# **Replacement of Lift Safety Circuit Brumby T-bar, Blue Cow**

## **Statement of Environmental Effects - ADDENDUM -**

**October 2012**

**Figure 3.1 – Approximate alignment of cable between Tower 3 and Tower 2, showing above-ground and trenched sections**

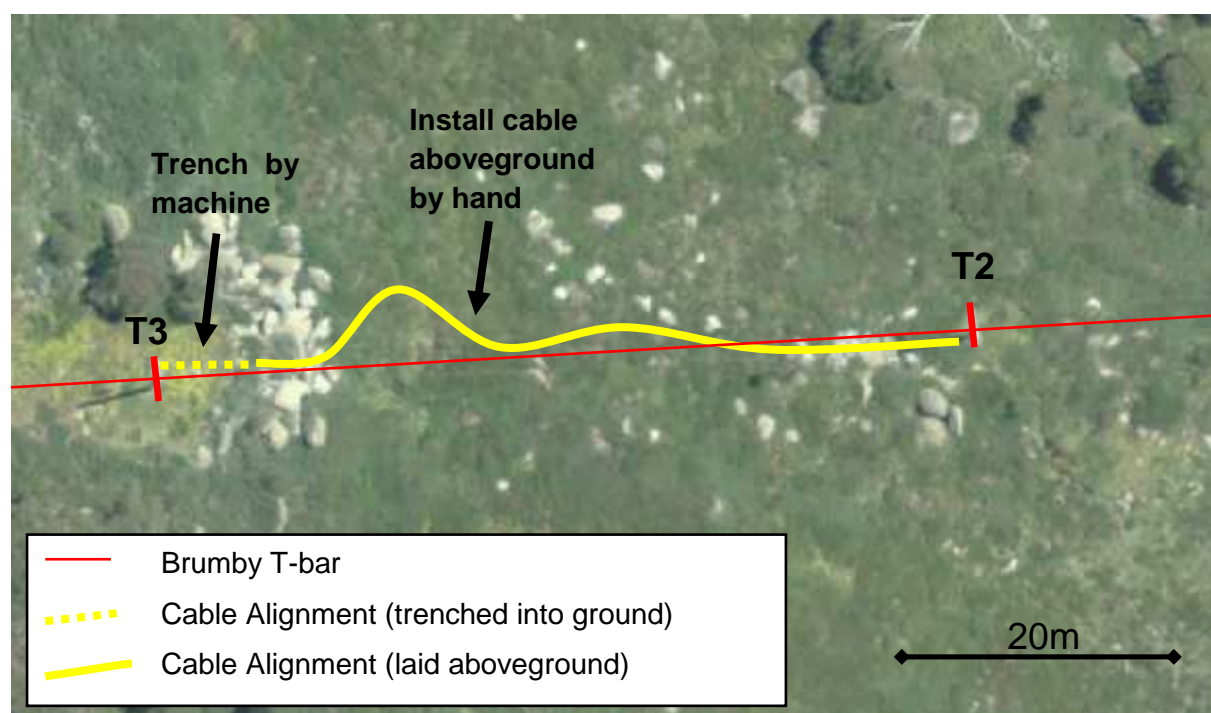
The proposal involves trenching the cable into the ground from Tower 3 to the rock wall. From here, the cable will be laid on the ground surface, between boulders and heath until it reaches the base of the wall. **From this point, the cable will continue on the ground surface diverting north from the T-bar line through areas of higher heath and boulder cover, to avoid a section of bog and wet heath.** The cable will then continue above ground along the T-bar alignment through a further area of heath and boulders, for a distance of approximately 30 metres until it reaches Tower 2 (see Figure 3.1).

This amendment relates to the above-ground laying of cable through areas of heath between Towers 2 and 3, to avoid damage or disturbance to an area of Montane Peatlands and Swamps endangered ecological community and Alpine Bogs and Associated Fens community. This is an amendment from the hand-trenching that was originally proposed through this section.

References in the original SEE to hand-trenching between Towers 2 and 3, and impact assessment on Montane Peatlands and Swamps endangered ecological community and Alpine Bogs and Associated Fens community are no longer relevant to this project. The remainder of the SEE content remains current.

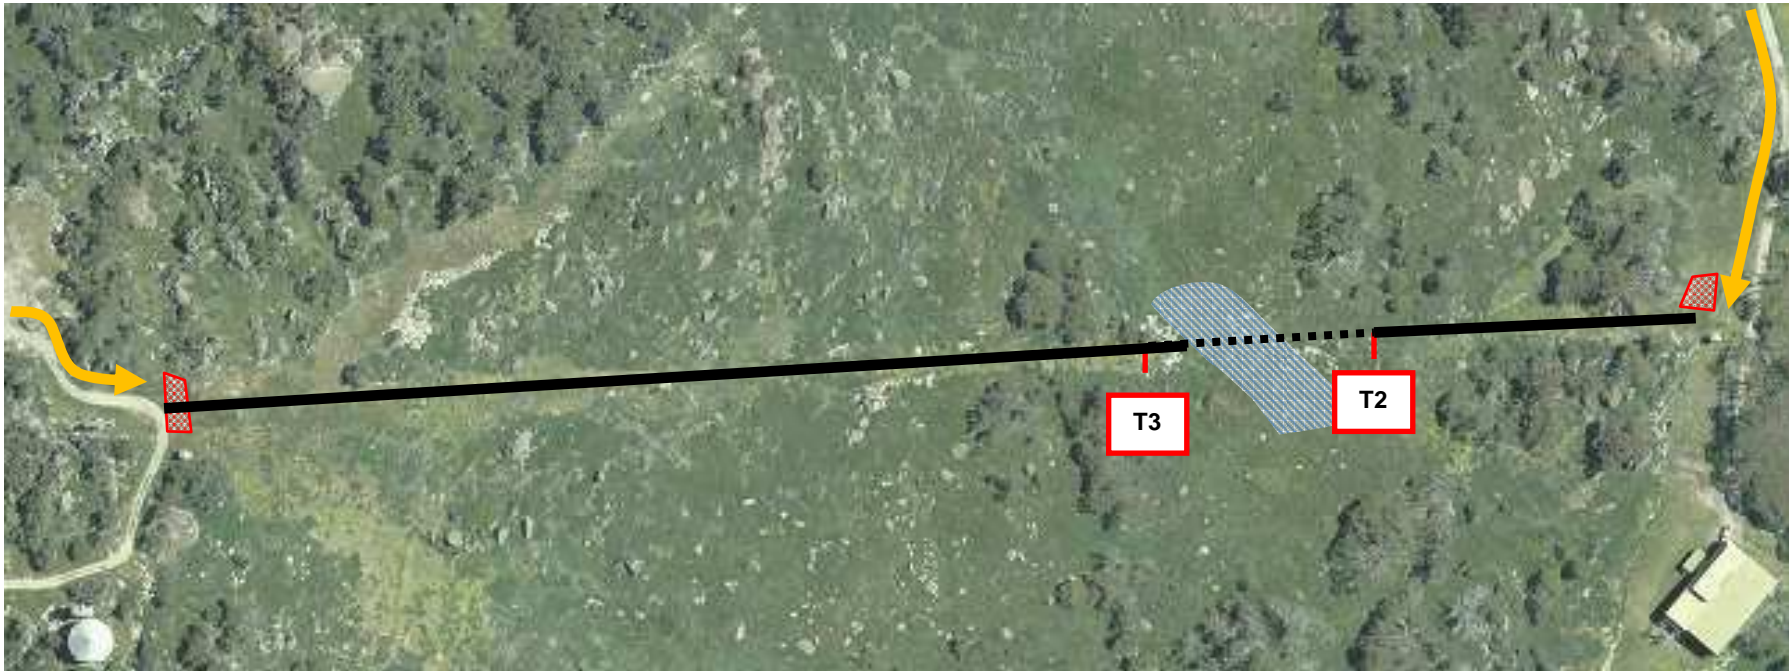
Map Legend	Towers 2 to 3 (Wet Area) Conditions	Map Legend	Remainder of Site Conditions
 	<ul style="list-style-type: none"> <li>• Minimise impact to wet area</li> <li>• No vehicle or machinery access</li> <li>• Cable to be placed on ground surface</li> <li>• Native seed only to be used in rehabilitation</li> <li>• Minimal hay to be used in rehabilitation</li> </ul>	  	<ul style="list-style-type: none"> <li>• Minimise vehicle and machinery access</li> <li>• Site access via established tracks</li> <li>• Establish staging areas on disturbed ground</li> <li>• Sod replacement where possible</li> <li>• Seed mix 50/50 Poa/Chewings to be used in rehabilitation</li> <li>• Layer of hay mulch to be spread for rehabilitation</li> </ul>
